BULLETIN T-65-23

SUBJECT: MAIN AND BIG END BEARINGS
HERALD AND SPITFIRE

DATE: MAY 6, 1965

PART No.
140111

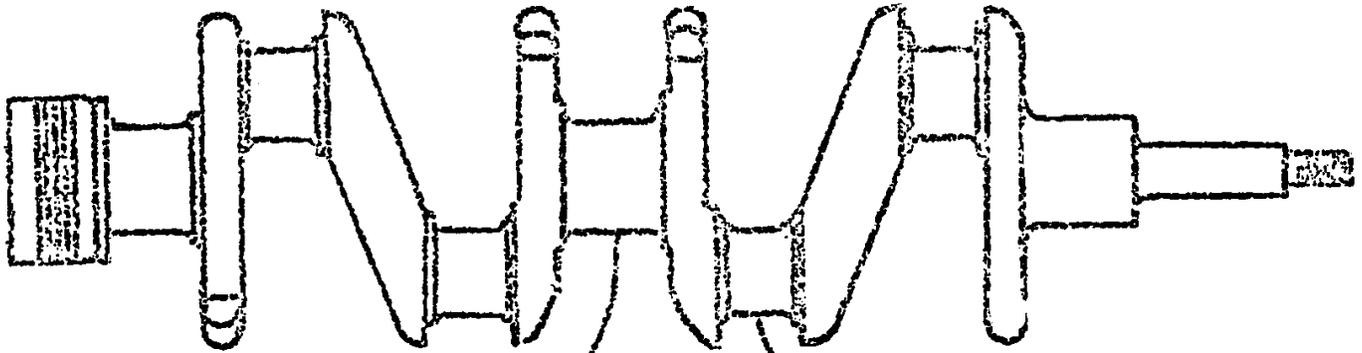
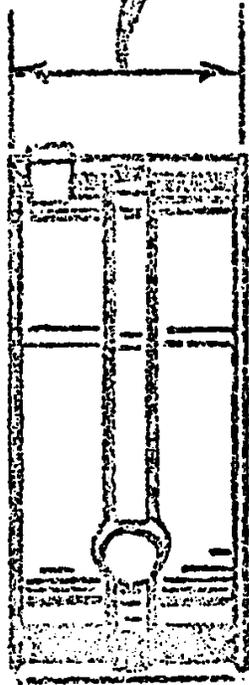
Narrower width main bearings, part number 140111, were introduced at the following ENGINE NUMBERS:

This was followed by narrower width big end bearings, part number 138211, at ENGINE NUMBERS:

Any replacements for engines after these numbers MUST be of the narrower type.

Earlier engines may be serviced with either narrow or original type of bearings.
